**SHEARON HARRIS NUCLEAR POWER PLANT, UNITS 2 AND 3
DOCKET NOS. 52-022 AND 52-023
RESPONSE TO REQUEST FOR ADDITIONAL INFORMATION LETTER NO. 007 RELATED TO
IDENTIFICATION OF POTENTIAL HAZARDS IN SITE VICINITY**

**Shearon Harris Nuclear Power Plant Units 2 and 3
Responses to NRC Request for Additional Information Letter No. 007 Related to SRP Section
02.02.01-02.02.02 for the Combined License Application, dated August 21, 2008**

Airports and Airways in Vicinity of HAR
FIGURE 2.2-202 Sheet 1 of 2
Rev. 1 Draft

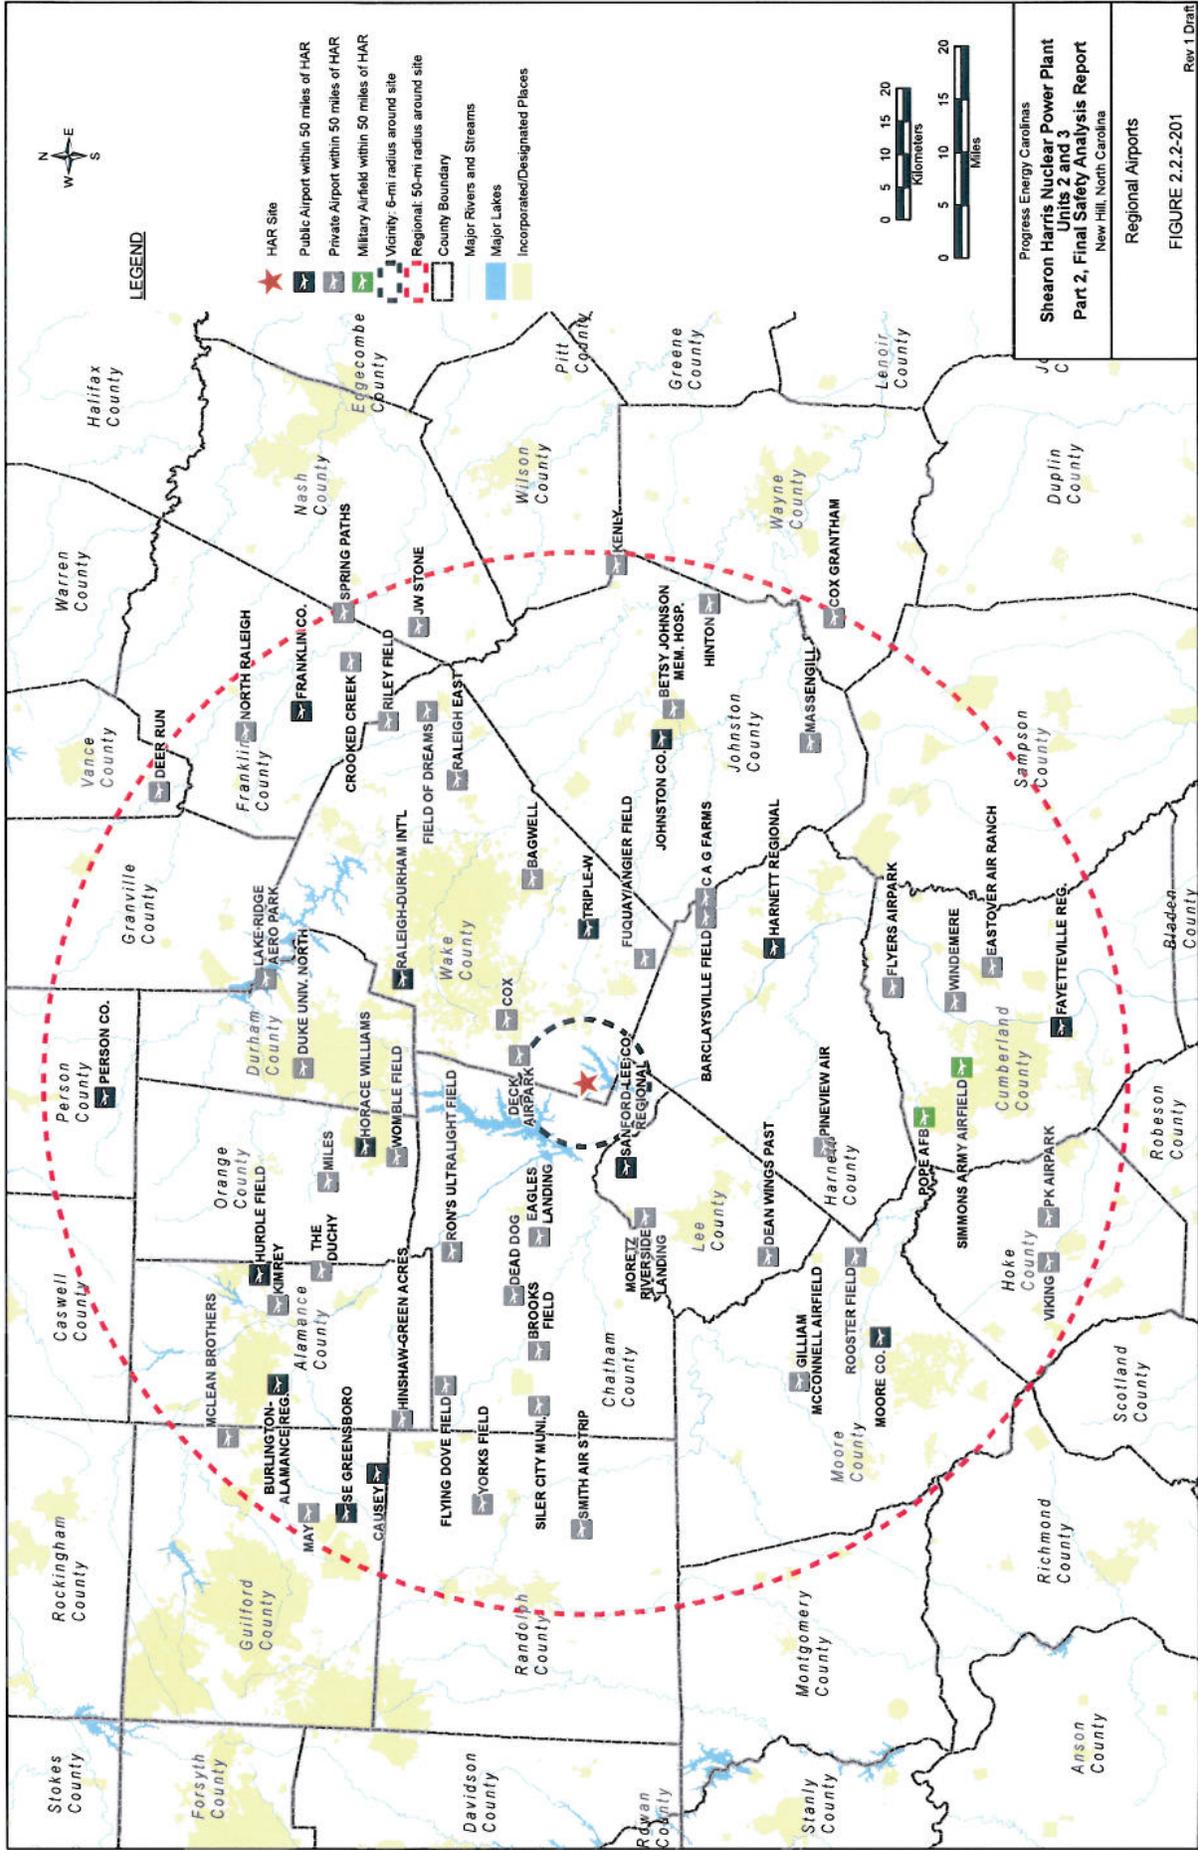
RG 1.206 provides guidance regarding the information that is needed to ensure potential hazards in the site vicinity are identified and evaluated to meet the siting criteria in 10 CFR 100.20 and 10 CFR 100.21. The FSAR Section 2.2.2.7 does not provide this information adequately to review this section. The NRC Staff's review indicates that there two Federal jet routes Airway J207 and J52- 55, whose nearest edges are well within 2 miles of HAR site. Therefore, in accordance with the acceptance criteria 3.5.1.6, the aircraft hazards associated with these jet routes should be evaluated and addressed in Section 3.5.1.6. Please evaluation, or provide justification for their exclusion.

The centerline of Airways V3-66-155, J207 and J52-55 are located 5.5, 2.6 and 3.8 miles, respectively, of the HAR site. The boundary of each these airways is 4 nautical miles from the centerline. Thus, the outer boundary of each of these airways is within 2 miles of the HAR site. Therefore, an aircraft hazards evaluation of these airways will be conducted. After the evaluation is completed, the revision to FSAR Subsection 3.5.1.6 (to be added to the FSAR in a future amendment) will be submitted to the NRC by January 30, 2009.

2. Replace FSAR Figure 2.2.2-202, in its entirety, with the version listed under **Attachments/Enclosures** below. A second sheet has been added to Figure 2.2.2-202 that indicates the routes of Airways J207 and J52-55.
